**New ECB Premises
Urban planning and architectural design competition**

**MINUTES OF THE JURY MEETING
ON 28/29 AUGUST 2003**

First phase of the Competition – Jury meeting held on 28 - 29 August 2003

Design 106

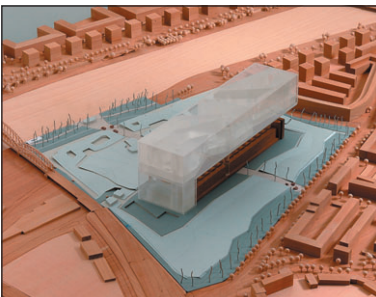
This outline concept was excluded due to non-compliance with the requirements of historical preservation. The fundamental appearance of the Grossmarkthalle is not respected because the new premises sits on top of the building and clads the west wing, shielding it from view. Furthermore, the Jury determined that the architectural idea underlying the concept would not be suitable for the ECB. Additionally, doubts were raised concerning the quality of the workplaces since most offices face into the atria with short distances between single buildings or are wrapped by a glass cube; few offices have direct contact to the outside. In the view of the Jury the later addition of the growth modules would not correspond with the original architectural concept.

Design 109

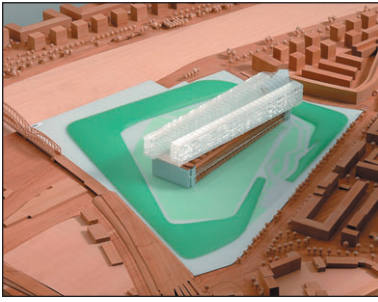
This outline concept was excluded due to non-compliance with the requirements of historical preservation in that the new premises overwhelms the Grossmarkthalle, taking away the autonomy and key characteristics of this monumental building. Furthermore, the Jury found that the concept would not reflect the ECB's values and would not convey the appropriate image. The feasibility of the extensions was called into question since they would create great construction challenges. The quality of workplaces was considered to be unsatisfactory as natural lighting and ventilation are reduced for the half of the offices that face the inner circulation corridor.

Design 112

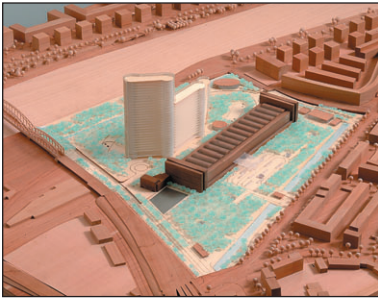
The Jury found this outline concept to be a conventional solution to an interesting and challenging programme, lacking in originality. The Jury could not see the interrelation between the new buildings and the surrounding area in particular the Grossmarkthalle. Furthermore, the singular connection between the new buildings and the Grossmarkthalle could result in circulation difficulties. Also, the Jury noted some deficiencies in the security requirements (western access not controlled, stand-off distances not respected).

Design 114

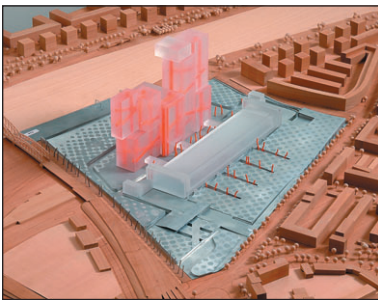
The Jury found the basic idea of the concept to be interesting, however the implementation of this idea was considered unconvincing and not able to reflect the ECB's values and would not convey the appropriate image. Furthermore, the office concept was found to be questionable due to the wasted space of open floor levels and a high amount of networking connections. These volumes appeared to be arbitrary with relation to their urban effect.

Design 115

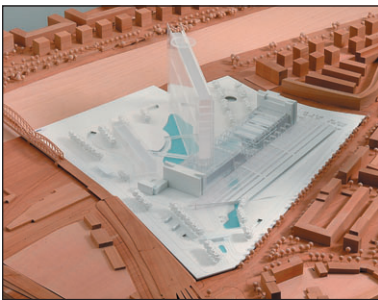
The Jury found that the outline concept would not reflect the image desired for the ECB and would not convey the appropriate image. Doubts were raised concerning the directionality of the building, which is further emphasised by its form. From a functional point of view the long corridor was criticised; "people movers" were considered as an unsatisfactory solution to circulation.

Design 125

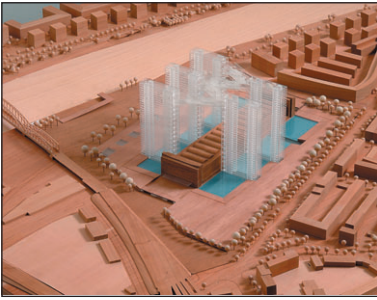
This outline concept was excluded by the Jury due to non-compliance with the urban planning goals for this area; the raised platform (height 3m) sitting on the site would create an edge/boundary to the city/surrounding neighbourhood. From a historical preservation perspective it was seen that the appearance of the Grossmarkthalle would be completely changed due to this overwhelming presence of this superstructure. Furthermore, the extensive use of water was noted as critical by the Jury.

Design 128

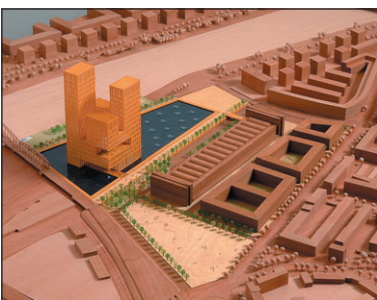
This outline concept was excluded because it did not comply with the programme as laid down in the Competition Brief. The Jury recognised the attempt to integrate the premises with the surrounding neighbourhood by adding buildings along Sonnemannstrasse dedicated to a public use, but the Jury was not convinced of the reasons for adding these facilities. Furthermore, there was seen to be an insufficient functional integration of the Grossmarkthalle. Also, doubts were raised concerning the quality of the workplaces.

Design 132

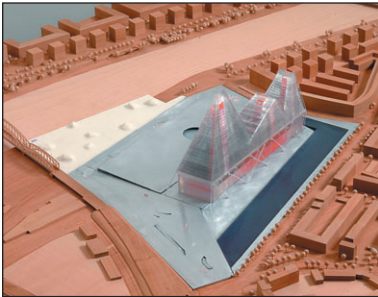
This outline concept was excluded due to non-compliance with the historical preservation requirements in that the new premises completely overwhelm and crush the Grossmarkthalle. The Jury found the proposed image for the ECB to be inappropriate. Furthermore, doubts were raised concerning the flexibility and quality of the workplaces; floor widths limit the possibility for natural lighting. Lastly, there was criticism regarding the insufficiencies of the landscape concept.

Design 135

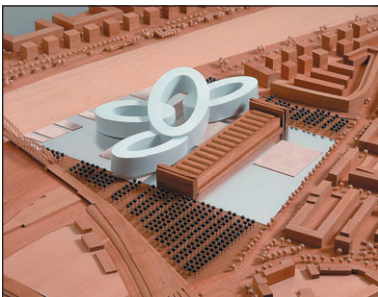
The connection between the new buildings and the Grossmarkthalle and the integration of the whole ensemble into the surroundings was considered to be unsatisfactory from an urban planning and architectural perspective. The connection between the rings of the buildings would create many workplaces that look into one another as opposed to the outside. Furthermore, the extensive use of water was criticised by the Jury.

Design 136

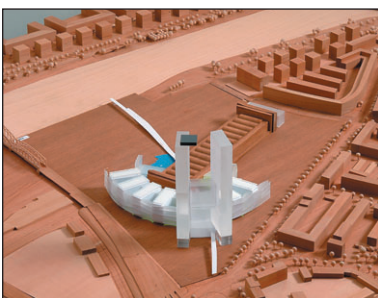
The Jury found the lack of interaction between the buildings and the integration of the whole ensemble into the surroundings to be unsatisfactory from an urban planning and architectural perspective. The non-compliance with the statutory setback requirements was also seen negatively by the Jury. Furthermore, the division between low-and high-rise buildings would create an undesired inequality in workplaces.

Design 137

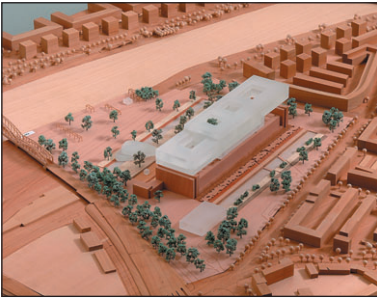
This outline concept was excluded by the Jury since it does not reflect the ECB's values and would not convey the appropriate image. The Jury found the office concept to be unsatisfactory in particular because half of the workplaces face towards the inner atria. Furthermore, the proposed growth modules would add to the heaviness to the design, which overwhelms the Grossmarkthalle. In addition, the landscape/open space concept is unclear. Furthermore, doubts were raised concerning the feasibility of the structure.

Design 149

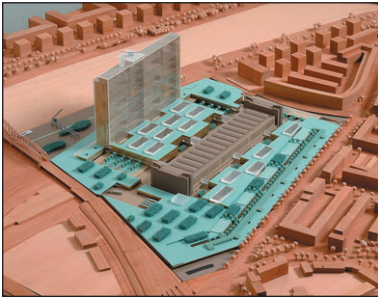
This outline concept was excluded by the Jury due to non-compliance with the urban planning goals for this area; the multi-storey base would create an edge/boundary to the city/surrounding neighbourhood. The Jury also found the access on the west side of the site to be problematic. Finally, the landscape and future insertion of the growth modules was seen critically as the entire site is built upon.

Design 150

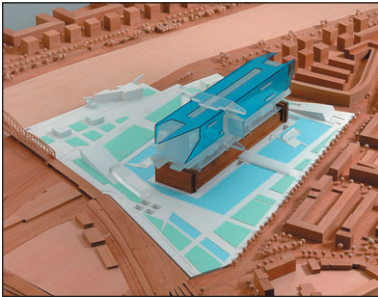
This outline concept was excluded by the Jury since it does not reflect the values of the ECB and would not convey the appropriate image. Also, this outline concept does not comply with the historical preservation requirements in that it undermines the Grossmarkthalle, distorting its fundamental appearance. Furthermore, doubts were raised concerning the feasibility of structure.

Design 153

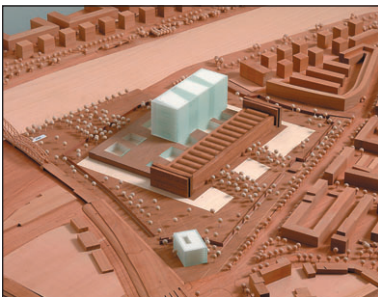
This outline concept was excluded by the Jury because it could not be successfully integrated into the surrounding neighbourhood; the security wall would create a boundary to the city/surrounding neighbourhood. Furthermore, the Jury found the quality of workplaces to be questionable due to the restricted views outside. Also, the refined structure would further limit office flexibility.

Design 155

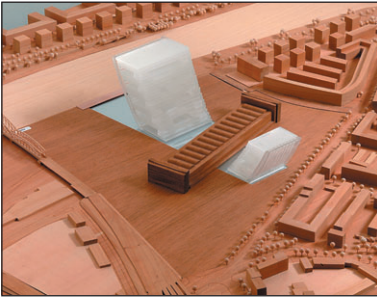
The Jury found that the outline concept would not reflect the values for which the ECB stands and would not convey the appropriate image. Furthermore, the design idea of disparate objects would not foster social interaction. The Jury found the internal circulation problematic due to the long distances and complex pathways between the separate towers. Lastly, there was criticism regarding an integrated approach to energy efficiency and design in particular with regard to the orientation to the facade.

Design 156

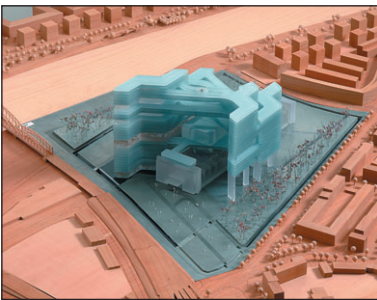
This outline concept was excluded by the Jury since it does not reflect the values of the ECB and would not convey the appropriate image. Also, the concept does not comply with the historical preservation requirements in that it undermines the Grossmarkthalle, distorting its fundamental appearance. The integration of the whole ensemble into the surroundings was considered to be unsatisfactory from an urban planning and architectural perspective. Furthermore, the Jury found that there are long and complicated walking distances such that orientation inside the building would be difficult.

Design 158

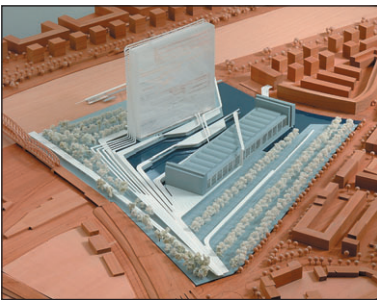
The size and proportions of the slab relative to the immediate surroundings was considered to be unsatisfactory from an urban planning perspective; the Jury could not see the interrelation between the new buildings and the surrounding area in particular the Grossmarkthalle. Furthermore, doubts were raised concerning the feasibility of the growth modules that would be placed between the new buildings and the Grossmarkthalle. Lastly, the landscaping was criticised by the Jury since it was not considered to be convincing.

Design 160

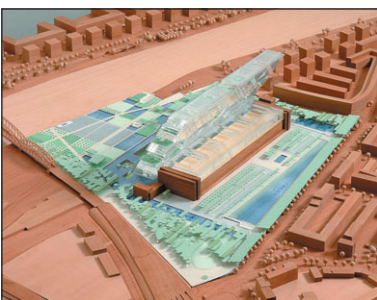
This outline concept was excluded by the Jury since it does not reflect the ECB's values and would not convey the appropriate image. Also, the outline concept did not comply with the requirements of historical preservation in that the new premises leans onto the Grossmarkthalle; the new slanted building overwhelms the Grossmarkthalle. Furthermore, the Jury raised doubts concerning the feasibility of the structure and of the growth modules, which would fill in the voids, used for "sky gardens". Lastly, the extensive use of water and landscaping was criticised by the Jury.

Design 161

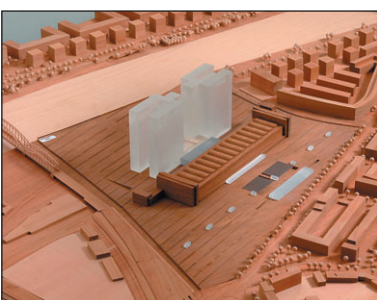
The Jury found this outline concept to be lacking in creativity; its mass and proportions were seen as an insensitive response to the design challenge. The Jury found the office concept to be unsatisfactory in particular because half of the workplaces face towards the inner courtyards with a questionable amount of natural lighting in these office areas. In addition, the landscaping concept is unclear.

Design 162

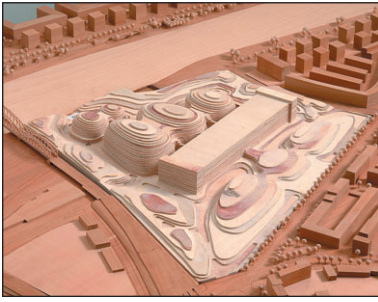
The connection between the new buildings and the Grossmarkthalle and the integration of the whole ensemble into the surroundings was considered to be unsatisfactory from an urban planning and architectural perspective. The Jury noted that the connection to the Grossmarkthalle through tunnels would create an unusable outside space. Furthermore, the quality of workplaces was seen to be questionable, as the middle zones have no contact to the outside and other areas only to inner courtyards. Lastly, the Jury did not consider the landscaping to be convincing.

Design 164

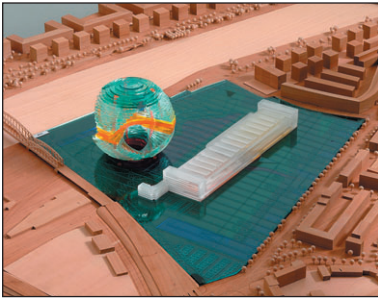
This outline concept was excluded by the Jury because it could not be successfully integrated into the surrounding neighbourhood. The Jury noted the lack of integration of the new premises with the growth modules and the Grossmarkthalle. Furthermore, it was noted that the inflexible form of the structure would not allow modifications. In addition, the Jury found the internal circulation to be questionable due to its disorienting nature.

Design 165

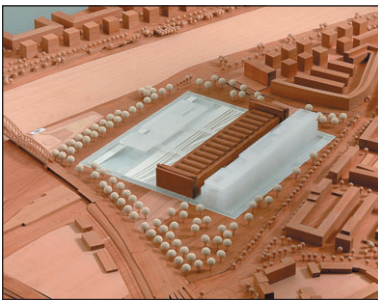
The Jury found that the outline concept would not reflect the ECB's values and would not convey the appropriate image. Furthermore, the Jury noted that the form does not follow the functional program as it is purely based on the geometry of the Grossmarkthalle. Additionally, the Jury noted the quality of workplaces to be questionable, as the short floor depth would limit flexibility. Lastly, the landscaping was criticised by the Jury since a water frame or moat surrounds the building.

Design 169

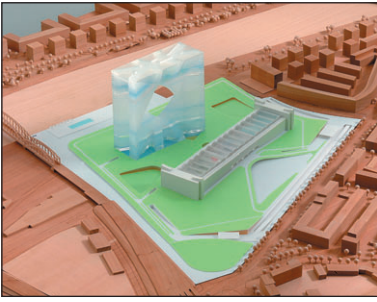
This outline concept was excluded by the Jury since it does not reflect the values for which the ECB stands and would not convey the appropriate image. Symbolically the institution would have no centre. Furthermore, the Jury criticised the concept for the extensions, which would call for a reduction in the grid and subsequent addition of more workplaces to each office floor. Finally, the internal circulation was criticised for the difficulties created by the central hole and the long walking distances from the main entrance to each workplace. Additionally, the Jury considered the floor plans to be less than optimal lacking the requested flexibility for the office concepts.

Design 170

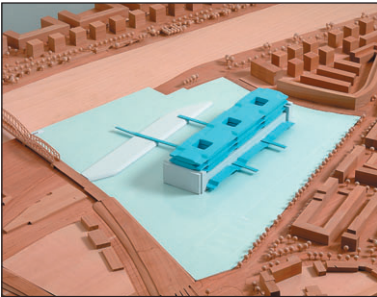
This outline concept was excluded due to non-compliance with the requirements of historical preservation; the appearance of the Grossmarkthalle would be overwhelmed by the structure. Furthermore, the Jury considered that the outline concept would not reflect the values of the ECB and would not convey the appropriate image. Lastly, doubts were raised concerning the quality of the workplaces, feasibility of the growth modules, and the landscape concept.

Design 105

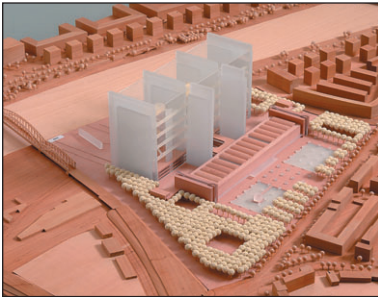
This outline concept was excluded by the Jury since it does not reflect the ECB's values and would not convey the appropriate image. Furthermore, the Jury noted that the successful integration into the surrounding neighbourhood would be difficult. In addition, the space efficiency with regard the large glazed volumes was seen to be questionable. Also, the structural engineering was criticised by the Jury. Finally, the concept did not provide the requested flexibility for the office space.

Design 110

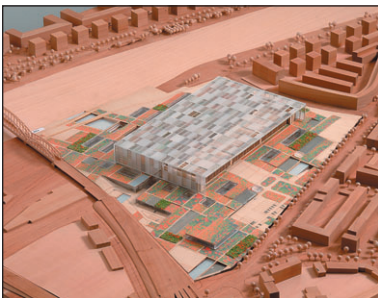
This outline concept was excluded because it did not comply with the requirements of historical preservation in that the new premises completely envelopes the Grossmarkthalle with a glass shell; the fundamental appearance of the Grossmarkthalle is therefore not respected. Also, the quality of workplaces was called into question, due to their lack of natural lighting, the redundancy of the offices and the feasibility of the growth modules. Finally, the Jury noted that the security concept had not been taken into account.

Design 111

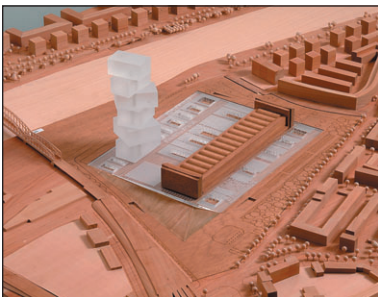
The Jury excluded this outline concept, since it does not reflect the values of the ECB and would not convey the appropriate image. Additionally, the rotating floor plan would limit the functionality of the office concept in terms of flexibility and reversibility. Furthermore, the growth modules were seen to be difficult to incorporate on top of the "energy lake".

Design 113

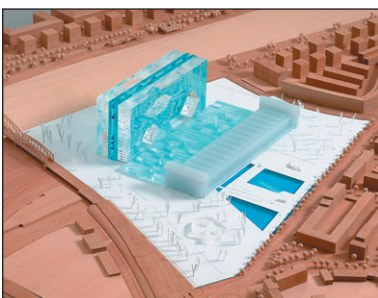
This outline concept was excluded by the Jury because it could not be successfully integrated into the surrounding neighbourhood; the new premises behind the Grossmarkthalle does not sensitively respond to the immediate area through its scale and form. The large voids would pose certain problems in the structure and internal circulation. Finally, the Jury noted that the growth modules were not integrated into the whole building ensemble.

Design 117

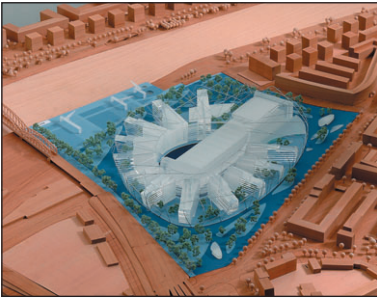
This outline concept was excluded due to non-compliance with the requirements of historical preservation; the Grossmarkthalle would be completely encased in the building shell. Furthermore, it was noted that the large glazed volumes would not be efficient in terms of space and would pose some construction difficulties in particular with regard to the growth modules. The high investment costs would not result in lower maintenance costs. Lastly, the extensive use of water and landscaping was criticised by the Jury.

Design 121

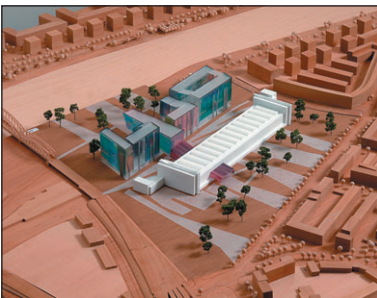
This outline concept was eliminated by the Jury due to the lack of information on the plans which was required at this stage. Information regarding the overall energy, landscape, security and access concepts was not available. In addition, doubts were raised concerning the quality of the workplaces; an unsatisfactory office layout would result in a lack of natural lighting for office floors facing interior courtyards. The growth modules would close in the buildings, limiting views to the outside.

Design 131

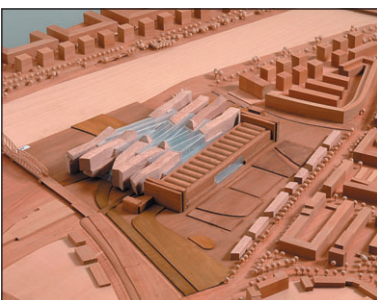
The Jury excluded this outline concept since it does not reflect the values for which the ECB stands and would not convey the appropriate image. Furthermore, the outline concept would not be successfully integrated into the surrounding neighbourhood, as it does not sensitively respond to the immediate area through its scale and form. In addition, the space efficiency with regard to the large glazed volume was seen to be questionable. Also, the quality of workplaces was called into question, due to their lack of natural lighting.

Design 139

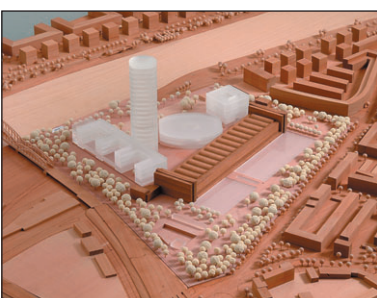
The Jury found this outline concept to be lacking in creativity; the forms and their interrelation with one another and the Grossmarkthalle appear to be arbitrary in response to the design challenge. Furthermore, the landscape concept was criticised, as the open space was merely residual space that would be difficult to use. Also, the Jury found the individual volumes to be questionable in terms of their space efficiency and internal circulation. The use of the existing space within the Grossmarkthalle was considered insufficient.

Design 144

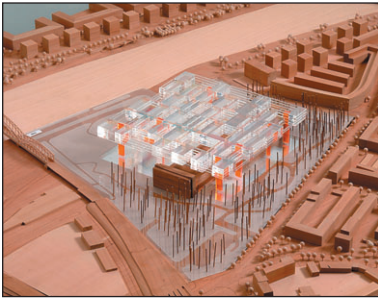
The connection between the new buildings and the Grossmarkthalle and the integration of the whole ensemble into the surroundings was considered to be unsatisfactory from an urban planning and architectural perspective. Furthermore, the feasibility of growth modules was called into question in terms of their construction. Lastly, the quality of workplaces was criticised, as there are limited views to the outside and long internal circulation distances between the office area and the Grossmarkthalle.

Design 147

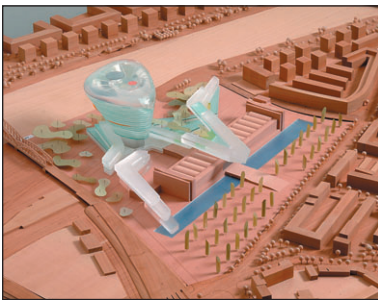
This outline concept was excluded because it did not comply with the energy/environment issues as laid down in the Competition Brief. The Jury found that the necessary high investment costs would be followed by high life cycle costs through both maintenance and energy consumption. Furthermore, the Jury criticised the difficulty of implementing the structure and the limits of flexibility and reversibility of the design once constructed. The design of a large calyx and horizontal green bands creates an undesired inequality in workplaces.

Design 103

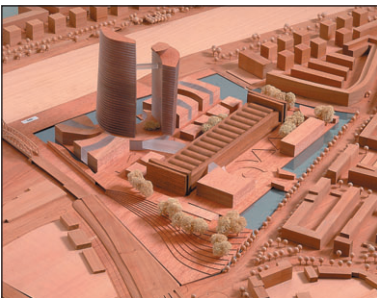
The Jury found this outline concept to be a conventional solution to an interesting and challenging programme. Furthermore, the division of the new premises into high- and low-rise building types would create an inequality in workplaces; the growth modules were seen to be questionable. Lastly, the extensive use of water was criticised by the Jury.

Design 123

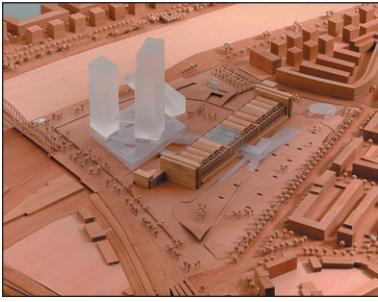
The connection between the new buildings and the Grossmarkthalle and the integration of the whole ensemble into the surroundings was considered to be unsatisfactory from an urban planning and architectural perspective. The division between the various building types would create an inequality in workplaces. Furthermore, the growth modules as a skyscraper between the Grossmarkthalle and the new base seemed questionable. In addition, the Jury criticised the internal circulation with respect to long walking distances between the towers.

Design 120

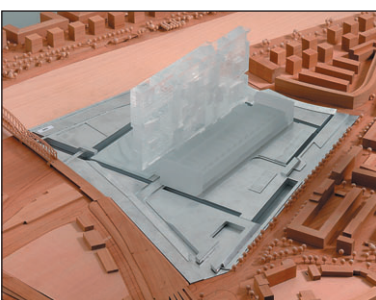
The Jury noted that the outline concept brings the Main river and the Grossmarkthalle into dialogue; it does not block the view of the Main river from the city. The concept was chosen because it has a strong image without overwhelming the Grossmarkthalle. It uses the unique concept of voids, which through their scale and proportion allow the large volume to interact with the surrounding neighbourhood. The Jury found the concept to be promising and that issues having to do with circulation (split-levels) and the feasibility of the growth modules (clip-ons limiting natural lighting) were to be worked through in the next phase.

Design 124

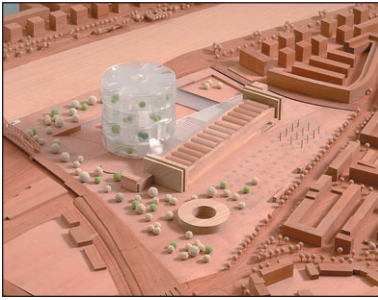
The Jury chose the outline concept to continue into the second phase as it integrates fully with the surrounding area. The new building is an object in dialogue with the Grossmarkthalle, which is to be preserved to its original status as far as possible. The interesting garden spaces throughout would create a high quality of working spaces as well as social spaces. The Jury also noted that the outline concept is extremely space efficient.

Design 133

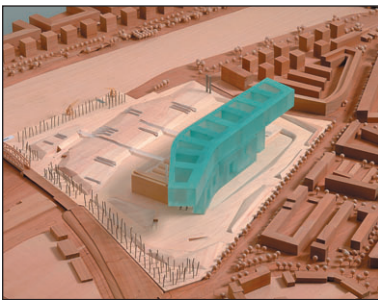
The Jury chose the outline concept to proceed to the second phase because the design mediates between the Grossmarkthalle and Sonnemannstrasse; serving as a link between the immediate neighbourhood and the ECB premises. Within this dialogue with the city the Grossmarkthalle is respected. Though the Grossmarkthalle would be slightly shielded from view from the north, it is not significantly altered or disrupted. Additionally, the Jury noted that the spatial and functional programme had been adequately fulfilled with a logical processional sequence between the functions.

Design 145

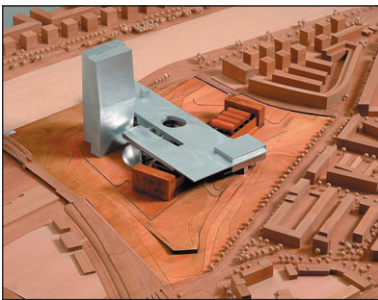
The Jury chose this outline concept due to its intelligent combination of old and new in a sculptural form. It uses a strong representative entrance, leaving the Grossmarkthalle visible from the north. The Jury noted that the quality of working spaces was high with multizones as “hanging gardens” between the bridges and internal circulation developed in relation to office spaces.

Design 157

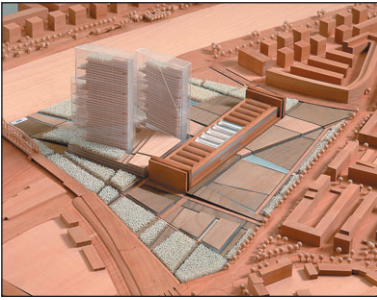
The Jury chose the outline concept because it would relate positively to the neighbourhood. Furthermore, the clear structure of the buildings continues in the landscape concept, which seemed highly developed with a large amount of green space, including inclined planes, varied water basins and roof gardens. Furthermore, the overall energy concept considers local environmental conditions such as wind, movement of the sun, noise and local energy potential. In addition, the Jury noted the high quality of workplaces that comes as a result of the energy/environmental considerations.
